Technical Service Information

THM 4L60-E

DELAYED ENGAGEMENT IN DRIVE AND/OR REVERSE

Figure 1

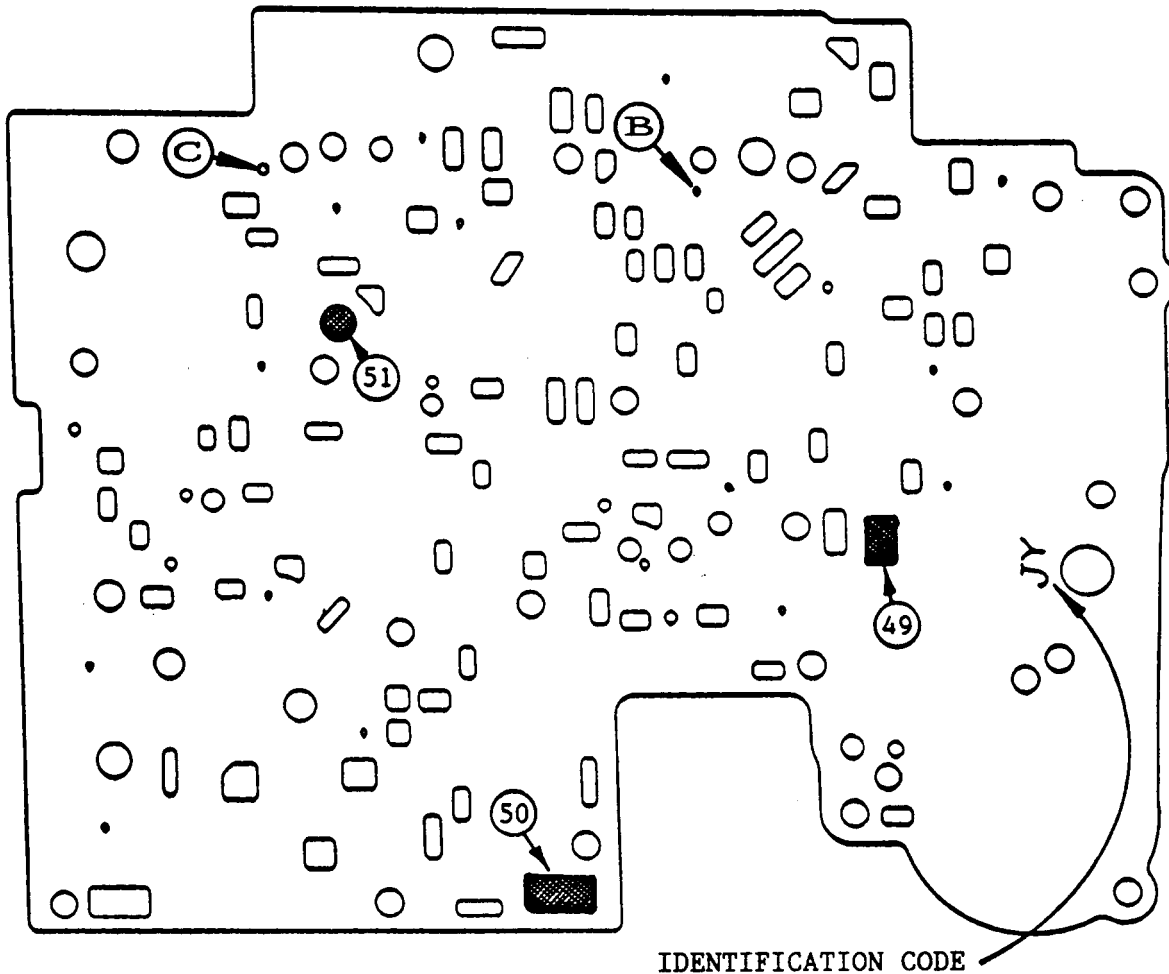
COMPLAINT: Delayed engagement when manual shift lever is placed in either drive and/or the reverse position.

CAUSE: The cause may be lack of volume of oil to either the forward clutch pack or the reverse input clutch pack.

CORRECTION: For a delay when placed in a forward gear, drill the hole in spacer plate marked "B" out to .125" diameter as shown in Figure 1.

For a delay when placed into reverse gear, drill the hole in spacer plate marked "C" out to .125" diameter as shown in Figure 1.

FOR A DELAY FORWARD DRILL HOLE "B" OUT TO .125" DIAMETER.
 FOR A DELAY TO REVERSE DRILL HOLE "C" OUT TO .125" DIAMETER.
